FACILITIES: Shearon Harris Nuclear Plant, Unit 1

SUBJECT: SUMMARY OF JANUARY 11, 2012, MEETING WITH CAROLINA POWER & LIGHT TO DISCUSS REALISTIC LARGE BREAK LOSS-OF-COOLANT ACCIDENT (TAC NO. ME6999)

Harris Realistic LBLOCA Question Response Meeting

Maximum Packing Factor [PF] Considerations

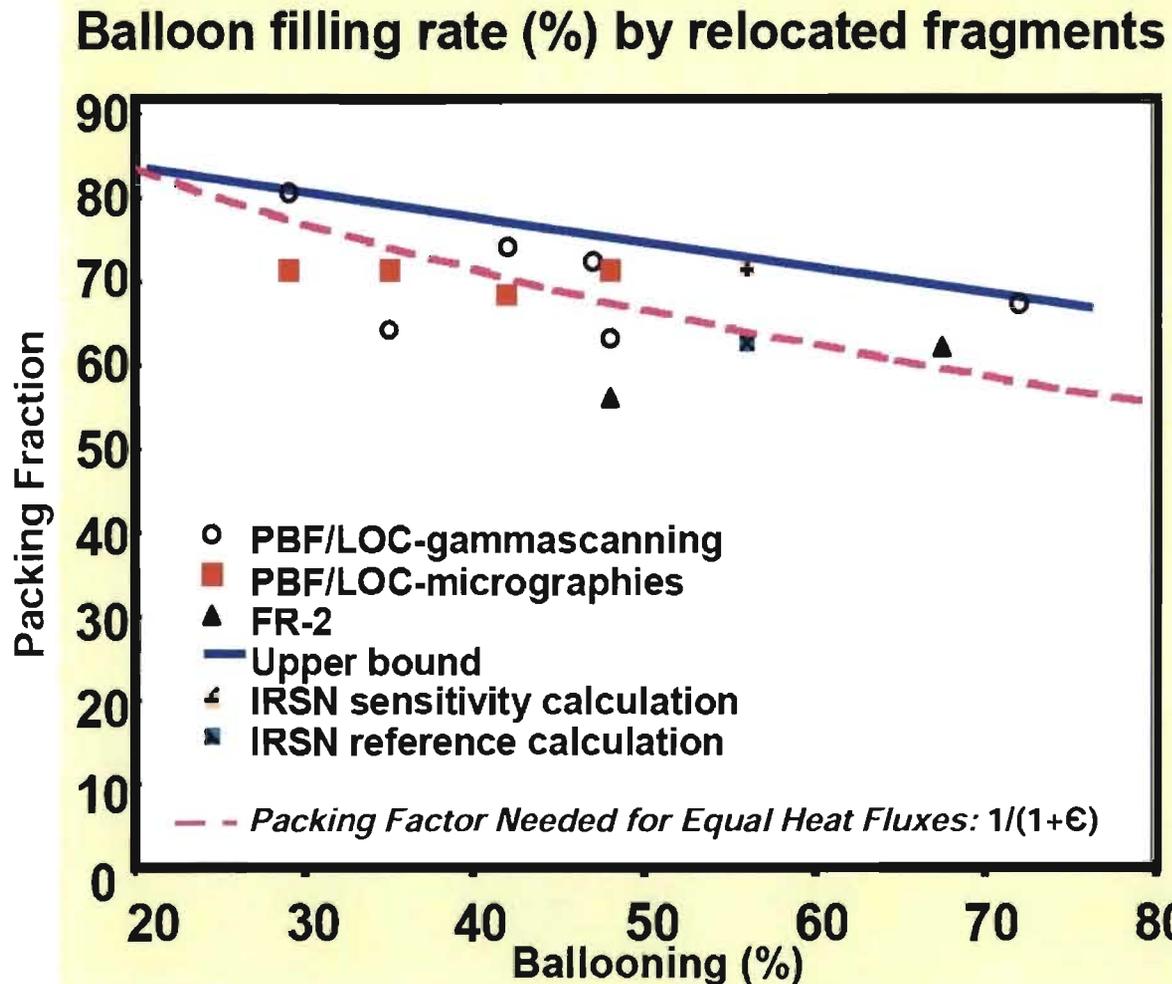
Question #1

- Only 1 gamma scanning data point at 80% packing fraction and it is at 30% strain
- Data results are in question due to material movement during the handling of the test rods
- Micrographies measurement is more accurate compared to gamma scanning
- PBF micrographic data shows 70% PF for rupture strain below 50%
- AREVA estimates 45% PF for strains near 70%

REBEKA-6 Test: Rupture rod cladding temp. & pin pressure

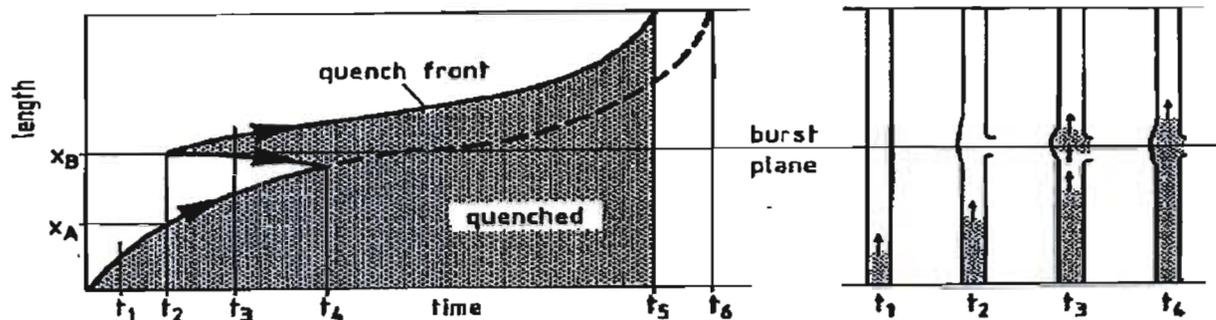
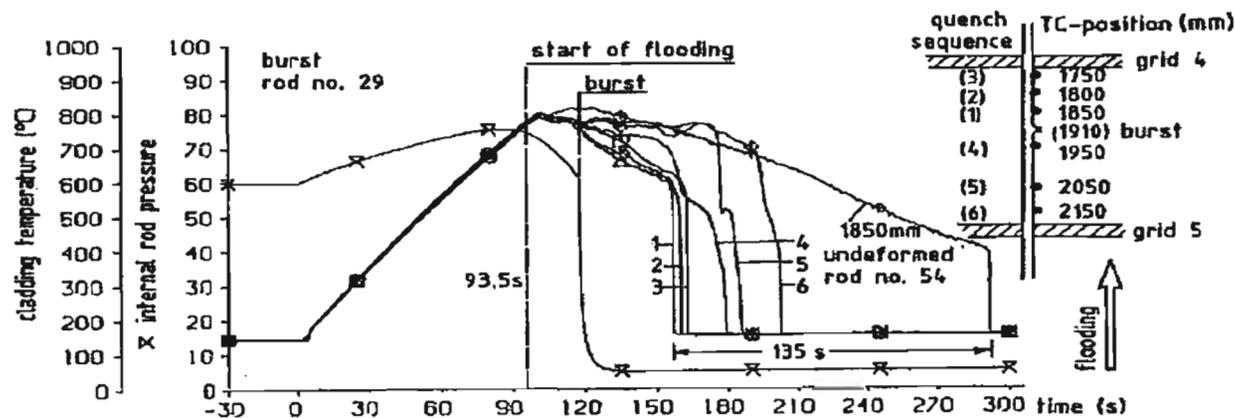
Explain how droplet shattering model incorporates the following droplet-dependent heat transfer effects:

- Inter-phase heat transfer
- Fluid-structural interactions including cladding, balloon, and spacer heat transfer to coolant
- Validate heat transfer modeling for these separate effects

Fig. 7 Premature quenching of burst Zircaloy claddings (schematic)
